Re: Docket No. 327 - The Connecticut Light and Power Company application for a Certificate of Environmental Compatibility and Public Need for the construction, maintenance, and operation of a proposed substation located off of Christian Street, Oxford, Connecticut.

Response to CSC-01 Interrogatories dated 03/21/2007
CSC-001, 002, 003, 004, 005, 006, 007, 008, 009, 010, 011

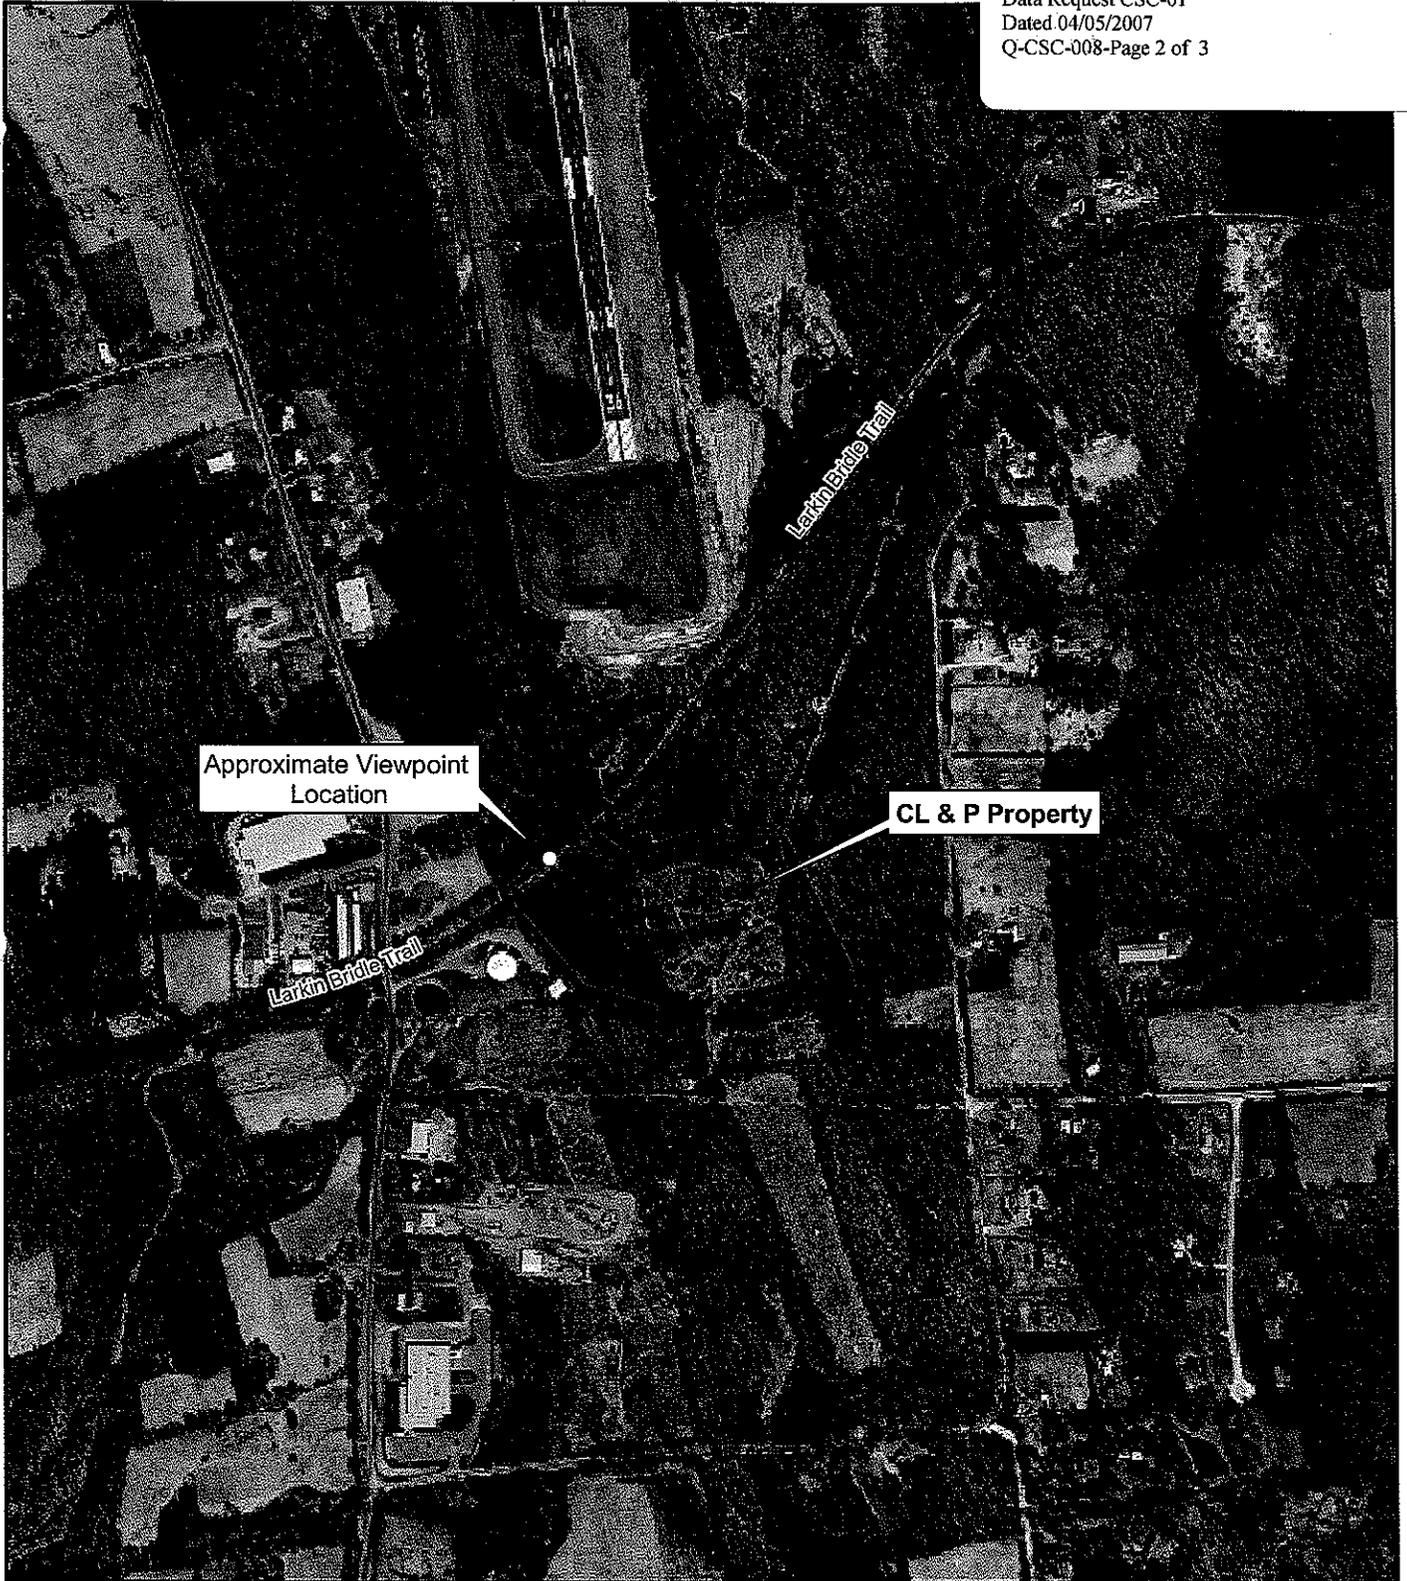
Question:
Three tree species are proposed in the Landscape Plan. What is the typical height of each species at maturity?

Response:
The three species of plants proposed on the Landscape Plan in the Application, include one tree species (red cedar) and two tall shrub species (arrowwood viburnum and gray dogwood). Red cedar (*Juniperus virginia*) can attain a height of up to 35-feet. Arrowwood viburnum (*Viburnum dentatum*) attains a height of 12 feet. Gray dogwood (*Cornus racemosa*) attains a height of 10 feet.
